Access Compliance Report

Public Rights-of-Way

Intersection ID: 18244	Main Street: CROSBY_RD	Cross Street: S_SHARON_AMITY_RD	Location: S
ADA ID: 3F18F418AEB1	Ramp Type: PerpDiag	Initial Pass/Fail: Fail	Overall Compliance: No
Severity Score: 22.5			
Codes/Mitigation Info/Possible Solution		Field Measurements/Component Compliance

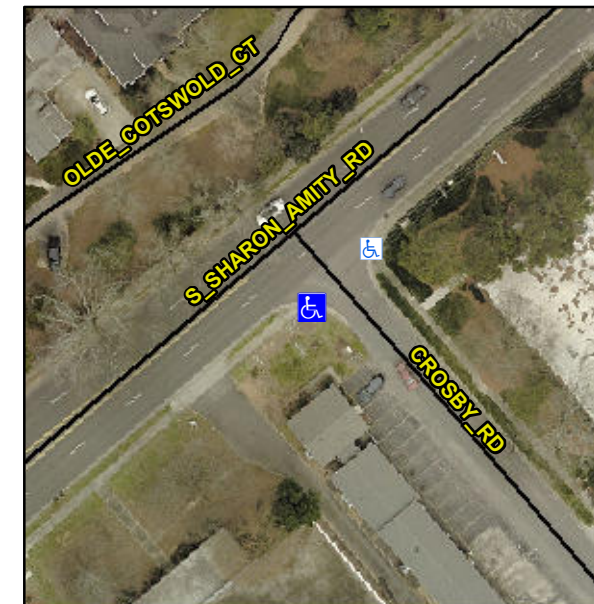
Not Found, R304.5.1, R304.2.2, R304.5.3

Compliance	Description	Data	Compliance	Description	Data
N/A	Ramp Length (in)	60.0	No	Ramp Slope (%)	8.9
No	Ramp Width (in)	37.0	No	Ramp XSlope (%)	4.3
N/A	Flare Type LT	N/A	N/A	Flare Type RT	N/A
N/A	Flare Slope LT (%)	N/A	N/A	Flare Slope RT (%)	N/A
N/A	Flare Traversable LT?	N/A	N/A	Flare Traversable RT?	N/A
N/A	Landing Length (in)	N/A	N/A	DWS Provided?	N/A
N/A	Landing Width (in)	N/A	N/A	DWS Contrast?	N/A
N/A	Landing Slope (%)	N/A	N/A	DWS Length (in)	N/A
N/A	Landing X Slope (%)	N/A	N/A	DWS Full Width?	N/A
N/A	Landing Curb? (Y/N)	N/A	N/A	DWS Offset (in)	N/A
N/A	Shared Landing?	N/A			
N/A	Gutter Ponding?	N/A	N/A	Gutter Slope (%)	N/A
N/A	Gutter Lip Ht (in)	N/A	N/A	Gutter X Slope (%)	N/A
N/A	Painted X Walk1?	No	N/A	Painted X Walk2?	No
	X Walk 1 Direction	To NE		X Walk 2 Direction	To NW
N/A	X Walk 1 Width (in)	N/A	N/A	X Walk 2 Width (in)	N/A
	X Walk 1 Slope (%)	2.2		X Walk 2 Slope (%)	0.4
	X Walk 1 X Slope (%)	1.1		X Walk 2 X Slope (%)	0.5

Remove & Replace Curb Ramp With Two New Directional Ramps or Equivalent.
